COLORADO
**Division of Reclamation,
Mining and Safety**
Department of Natural Resources
Rm 215
1001 E 62nd Ave
Denver CO 80216

RE: Two Rivers, Permit No. M-1998-038, Technical Revision (TR-7), Preliminary Adequacy Review

MINING PLAN

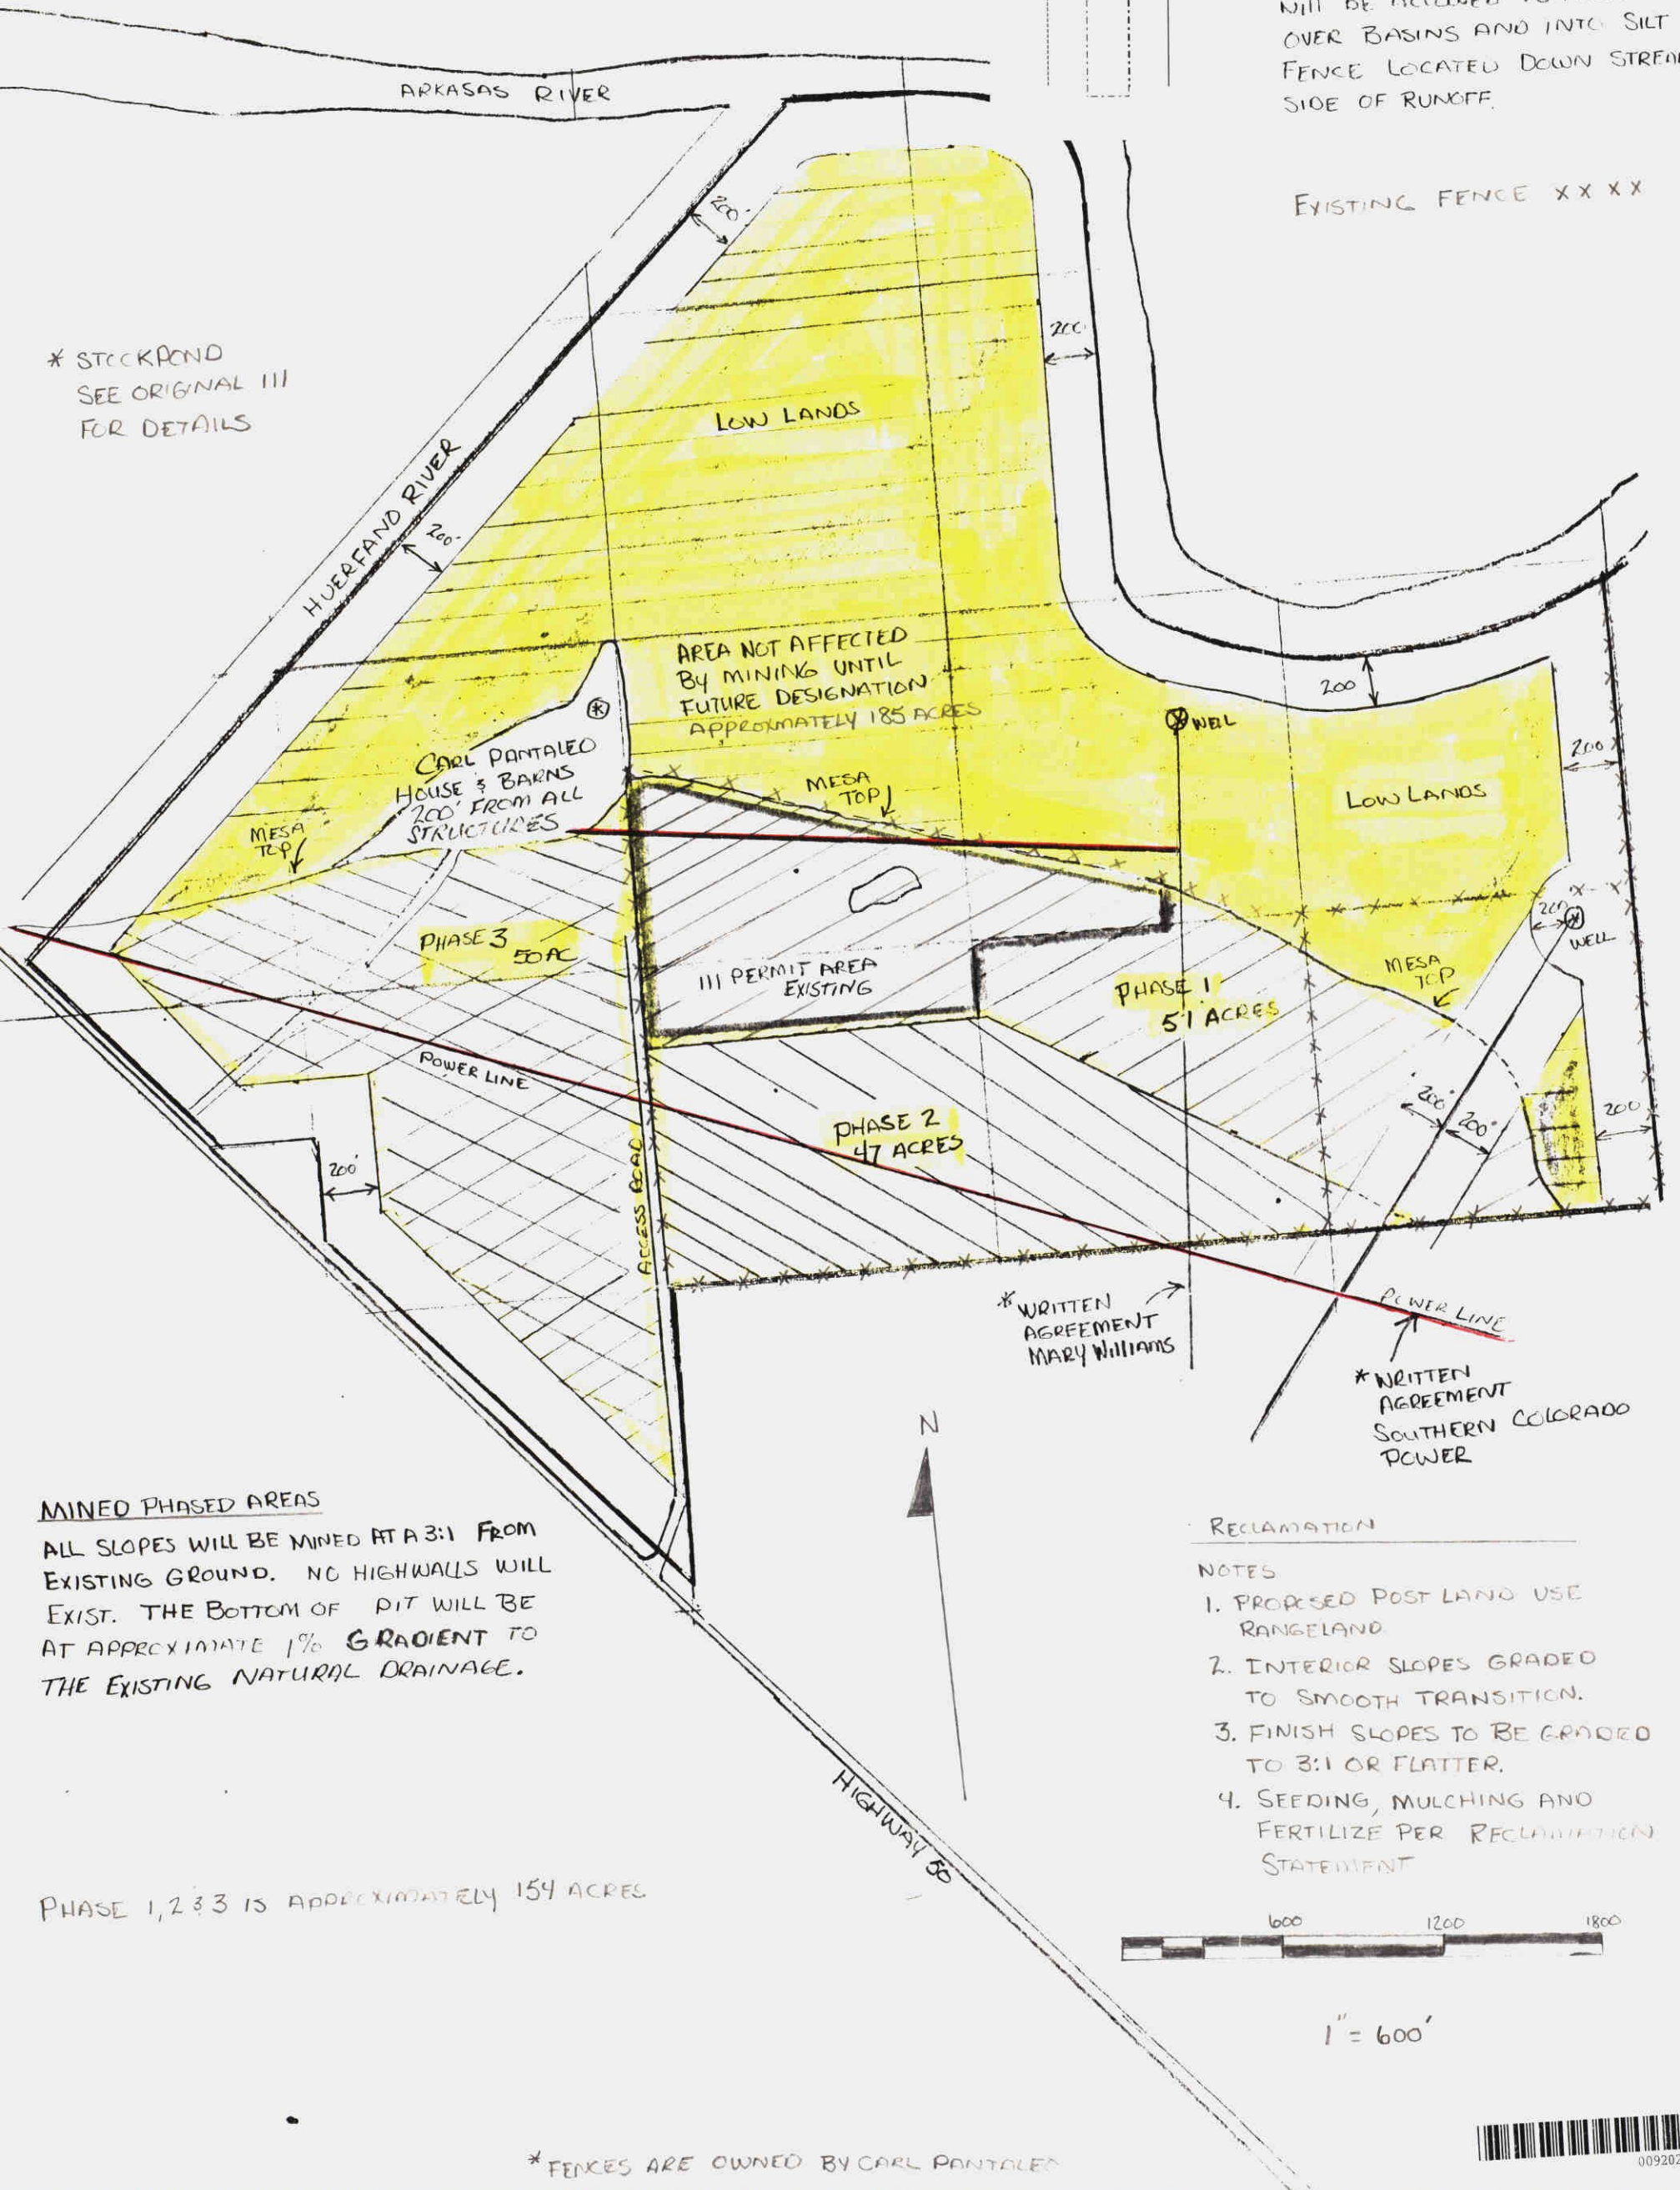
- i. Attached is a copy of the originally approved mining plan map. The area highlighted in yellow is not approved to be affected by mining at this time. If the 150 acres requested to be affected via TR-7 is within this new area, the permittee must instead submit an amendment application pursuant to Rule 1.1(6).

- iii. Additionally, please submit an updated mining plan map that illustrates the area to be affected by mining. Also, please update the current phasing plans or illustrate that the affected land is equivalent to the maximum allowed to be affected at any one time if that is your intention.
